PCN	Product Change Notification	De-22-07-0604	
Product	SMC	Date of Publication:	
		20.07.2022

Title: SMC adaption of tolerance

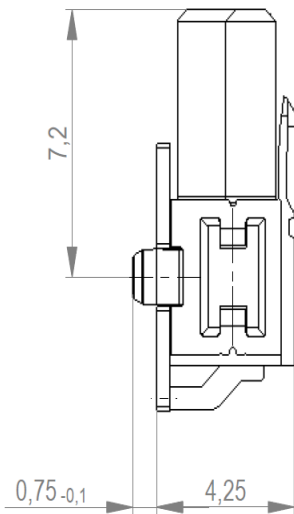
Valued Customer,
we adapted the tolerance of dimension 0.75 to the current state from -0,05 to -0,1.

This change will be operated without partnumber change and as it does not effect function of the product it is valid immediately.
